**CORRIGENDUM NO. – II**

**Sub:** Construction of Hard Stand with Land Ties, Brackets and Service Trench including allied Electrical works at Nhava Yard, MDL

**Ref:** Tender no. 1900000182 dated 09 Feb '24.

ISMB 350 400MM  
LONG

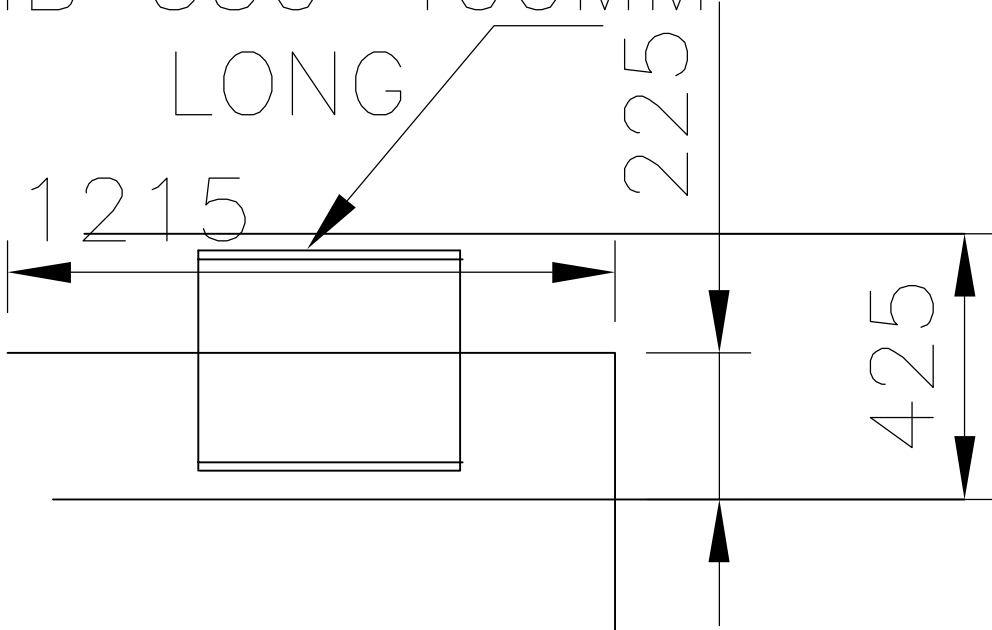
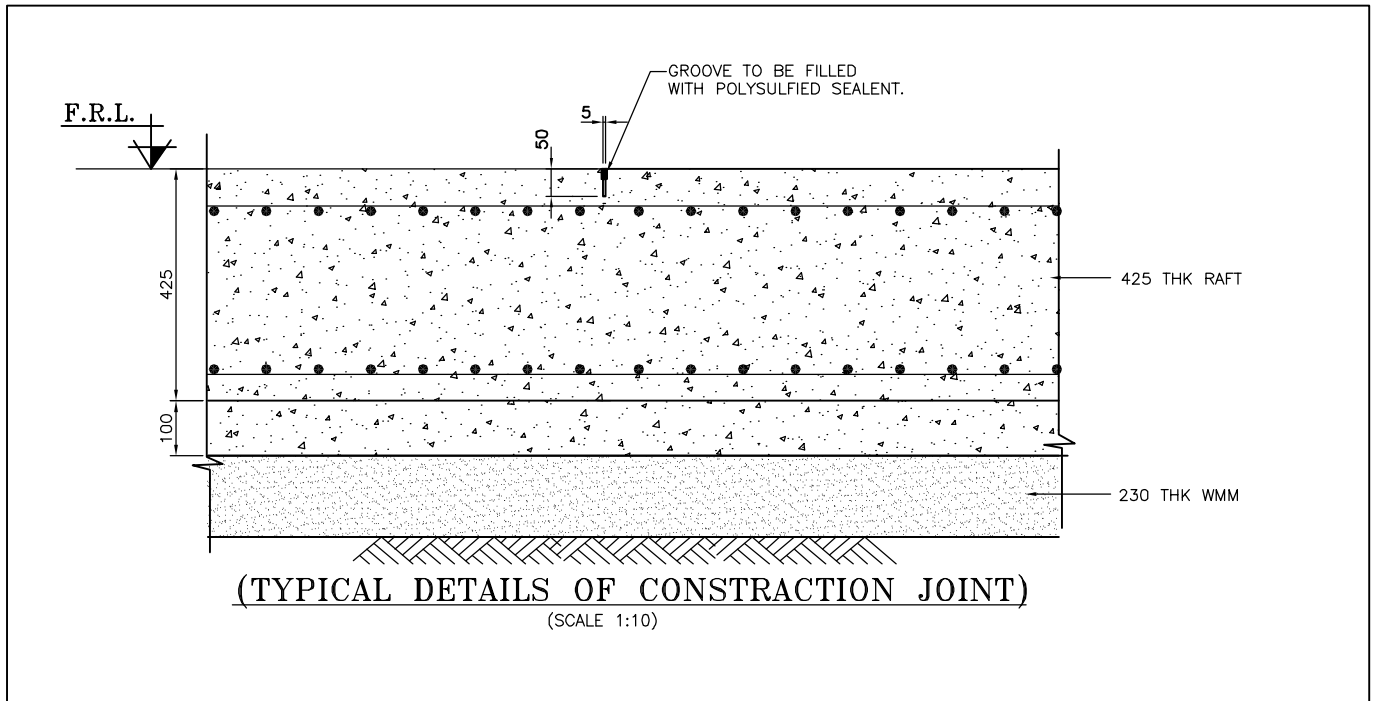
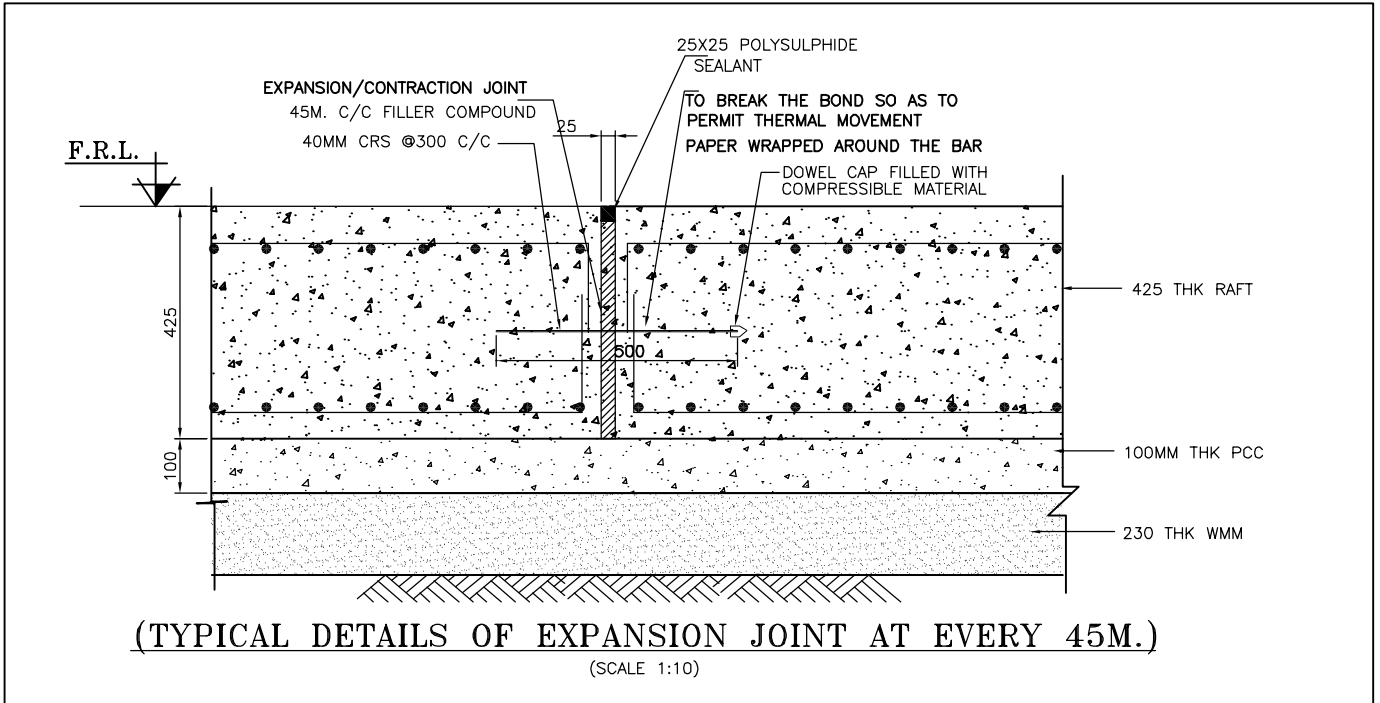
Sr. no.	AS PER TENDER DOCUMENT				Clause Description	CLARIFICATION SOUGHT	Response
	Volume	Section	Page No.	Clause No.			
19	Price Bid Part II	Price Bid Part II CORRIGENDUM NO. - 1	2	BOQ Item 100/70 steel anchor dowel bars	<p>Providing and Fixing steel anchor dowel bars In open foundations including drilling holes 150 mm dia. in weathered rock, providing and placing in position 32 mm dia. dowel bars 2.5 m in weathered rock and all other layers above weathered rock, effectively grouting the holes with cement &amp; Cebex etc. complete and as specified and directed by Engg. In Charge. (Grout shall be filled in the hole first and bars inserted and pressed in the drilled hole).</p>  <p>07 HARD STAND ROCK (SECTION AA')</p>	<p>As per Technical specification Page no 13 of 86: <u>1 nos. of CRS steel bars of 32mm diameter (Fe 500) conforming to IS 1786 as per drawings will be cut to length of complete anchor including that required for development length (60D) in raft/footing portion. These 2 bars shall be bundled by providing tack welding at every 1m c/c. Bars are to be taken up to top of raft/footing.</u></p> <p>In Drawing no STR/TD/001 showing 1 no of Tor steel Rebar and above Specification mentioned 2 bars to be bundled. Please clarify the number of bars to be provided in one land bracket tie.</p> <p>Development length mentioned as 60D in raft portion, means 60x32 =1920mm length of bar to be placed in 780mm base (WMM,PCC,Concrete). For more clarity Please provide the detail drawing showing the Re bar connection with ISMB 350(Land Ties).</p>	<p>Kindly refer tender drawing &amp; refer the addendum details attached for lap length</p>

20	Drawing STR/TD/001	CORRIGENDUM NO. - 1	2		 <p>DETAIL "W" PLAN OF HARD STAND ROCK ANCHOR DETAIL</p>	<p>As shown in drawing the 6 no's Anchor bolts up to Hard strata - Please provide the diameter and specification of Anchor Bolts . Also provide the drawing for Anchor bolts connection with Hard rock.</p>	<p>Kidly ignore the 6 Nos. of ancho bolts details</p>
21	Clarifications to bidder's queries- Annexure C, Sr.no.9	Enclosure 19-BOQ	5	BOQ Item 300/20- Heavy duty Grating	<p>Drawings of HD grating have been provided in Corrigendum-1, however the specifications/grade of steel has not been specified.</p>	<p>Please provide specifications/grade of steel to be used in Heavy duty Grating.</p>	<p>Grade of structural steel is Fe 250.</p>
21	Construction Joint					<p>Please provide the construction joint detail drawing on Hard stand</p>	<p>Kindly refer addendum details/drawing attached for Construction Joint.</p>
